Item Name: Crosstube Turning Detail

DART AEROSPACE LTD		Work Order: 87560
Description: Crosstube Assembly (205/212/412 High Fwd)		Part Number: D212-664-141
Inspection Dwg: D212-664-141 Rev: D		Page 1 of 2

DRAWING NO. D212-664-141	TITLE XTUBE ASSY (205/212/412 HI FWD)	REV. D	DART AEROSPACE LTD ENGINEERING ORDER		D.E.O. NO. D212-664-141-D-1	SHEET NO. SHEET 1 OF 2	SCALE NTS
DRAWN	CHECKED	MFG. APPR.	APPROVED	DE APPR.			
DATE 11.04.07	DATE 11.04.11	DATE 11.04.12	DATE 11/04/12	DATE 11.04.12

ADD AN INSPECTION WINDOW TO UNDERSIDE OF CROSSTUBE.

D212-664-141TRN
TURNING DETAIL

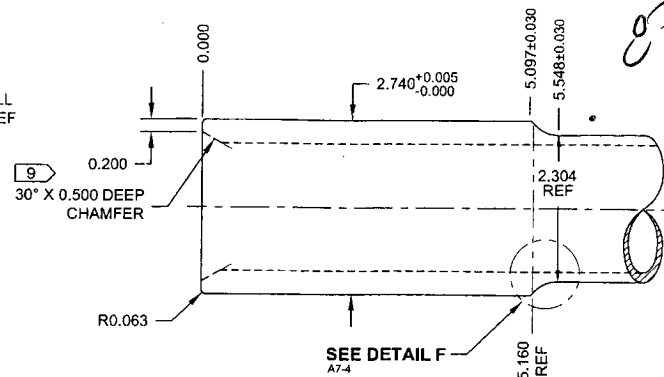
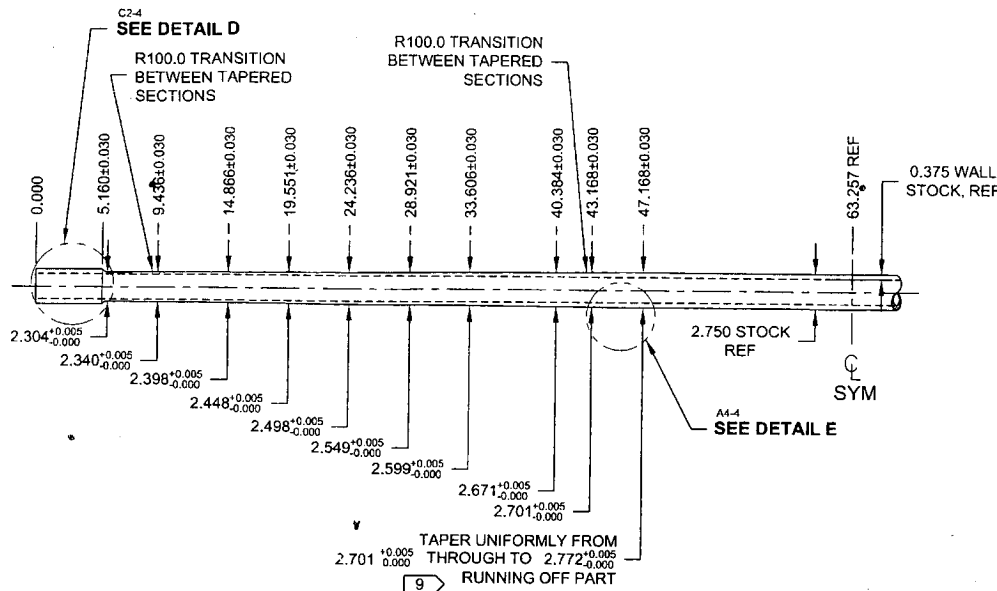
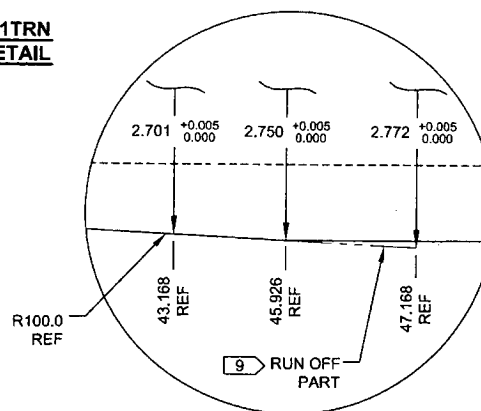
Root Cause	Date	Step	Qty	Description of work order update or Non-conformance	Initial Chief Eng	Action Description	Sign & Date	Verification	QC Inspector
Doc/Data <input type="checkbox"/>	12/8/13	100	1	Cuff is 0.006" below tolerance on O.D.	DAS 12/8/13	Acceptable	DAS 12/8/13	DAS 16 12/06/13	DAS 16 12/06/13 AS 2002
Equip/Tooling <input checked="" type="checkbox"/>									
Operator <input type="checkbox"/>									
Material <input checked="" type="checkbox"/>									
Setup <input type="checkbox"/>									
Other <input type="checkbox"/>									
Process <input type="checkbox"/>									
Supplier <input type="checkbox"/>									
Training <input type="checkbox"/>									
Unapproved <input type="checkbox"/>

Cuff out of tol.
(Tapered - Ovality)
2.740" - 2.734"

**D212-664-141/-141B
ASSEMBLY DETAIL**

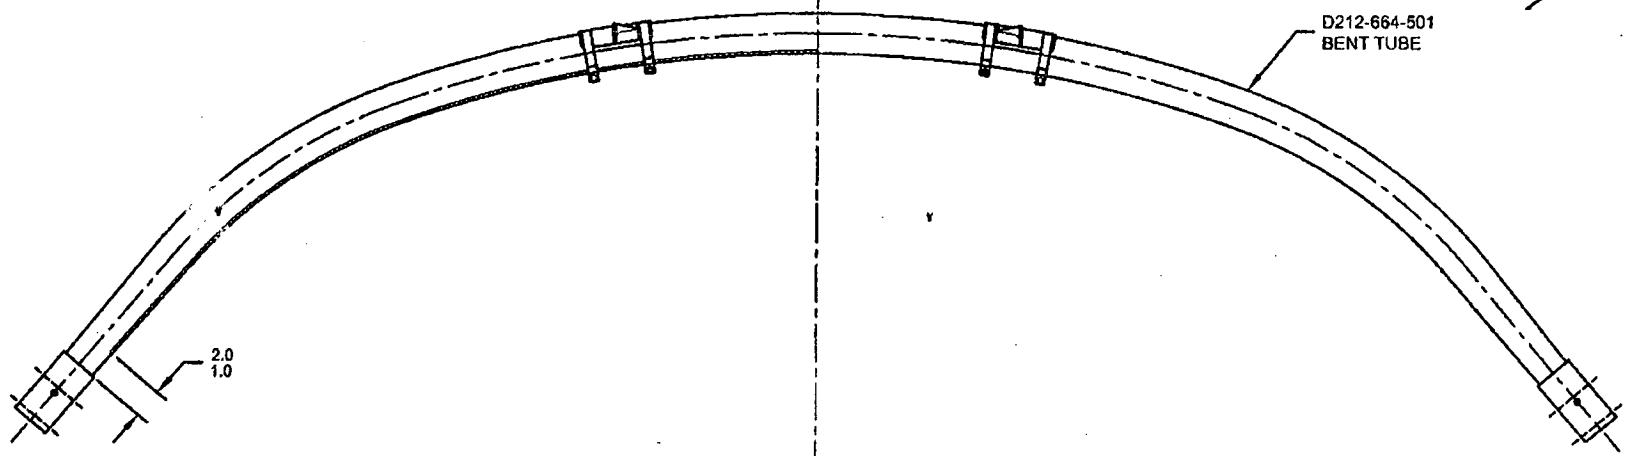
NOTES 2 OF SHEET 1 IS AMENDED AS FOLLOWS:

- 2) FINISH: CHEMICAL CONVERSION COAT PER DART QSI 005 4.1
PRIME INSIDE AND OUTSIDE PER DART QSI 005 4.2
MASK UNDERSIDE OF CROSSTUBE AS SHOWN (HATCHED AREA) AND
PAINT OUTSIDE PER DART QSI 005 4.2
REMOVE MASKING AND APPLY CLEAR COAT

MASK AREA PRIOR TO PAINTING,
REMOVE MASKING AFTER PAINT
AND APPLY CLEAR COAT
